The Foreign Correspondents' Club of Japan: Press Conference  
April 27, 2015, Monday, 15:00-16:30

Japan's first post-Fukushima approval of a Nuclear Power Plant (NPP) issued by the Nuclear Regulation Authority (NRA) to the Kyushu Electric Power Co., Inc. on Sept. 10, 2014 is **illegal**.

The NRA has violated its own legal regulatory requirements regarding the seismic safety assessment of the Sendai NPP in southern Kyushu.

**A source model of the Mw 9.0 Nankai trough eq.**  
 (Study Team of the Cabinet Office, 2012)

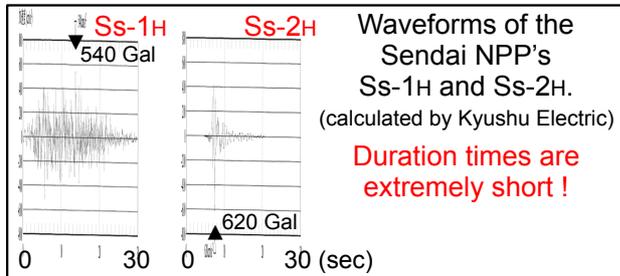
**The source model by the Kyushu Electric is insufficient!**

Taking the Nankai trough earthquake into account is indispensable in the formulation of the **SSM** for the Sendai NPP.

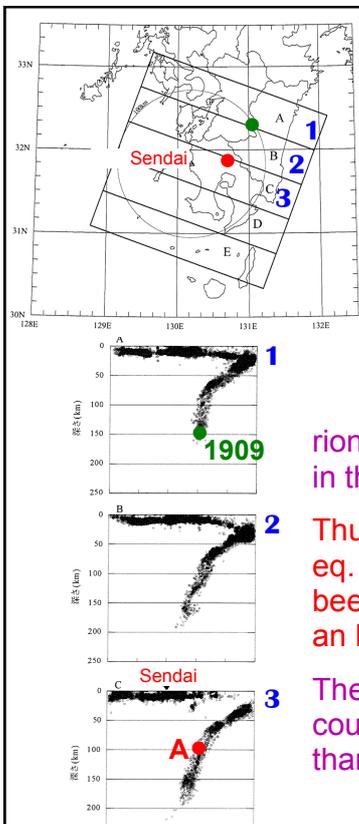
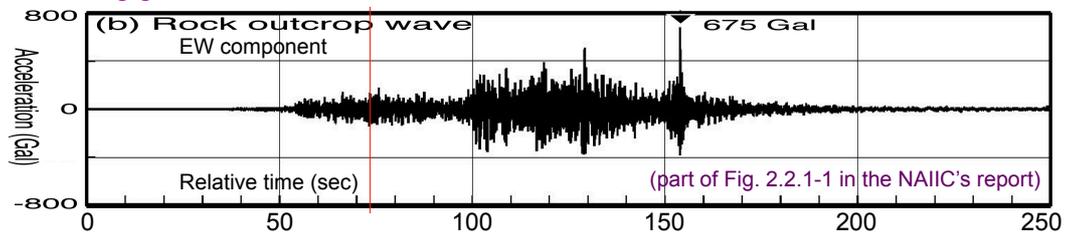
If the ground motion due to the Mw 9-class great Nankai trough eq. is formulated by setting up the possible maximum fault parameters, the ground motion may exceed Ss-1.

The duration of the ground motion of the anticipated great Nankai trough eq. is surely very long.

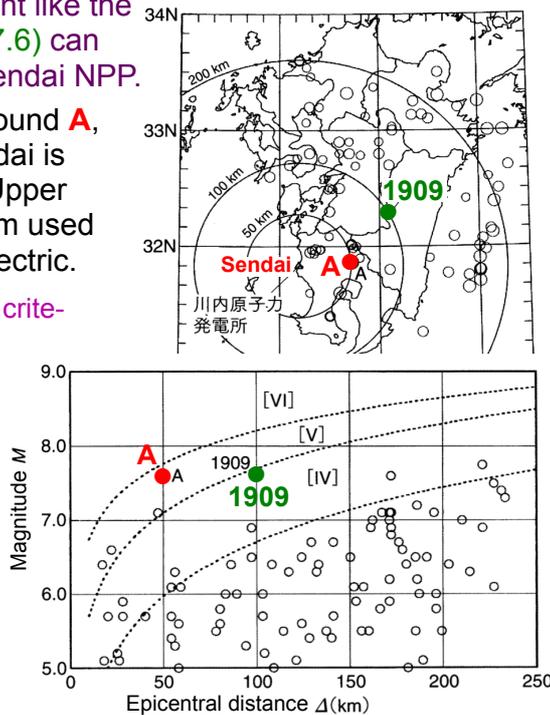
Concerning **intraslab earthquakes**, since the slab exists beneath the whole of Kyushu from north to south, an event like the 1909 eq. (M 7.6) can occur near Sendai NPP.

If it occurs around **A**, the SI at Sendai is estimated 5 Upper by the diagram used by Kyushu Electric.

This meets the criterion for inclusion in the **EQFI**.

Thus, an Intraslab eq. should have been selected as an **EQFI**.

The magnitude could be larger than 7.6.
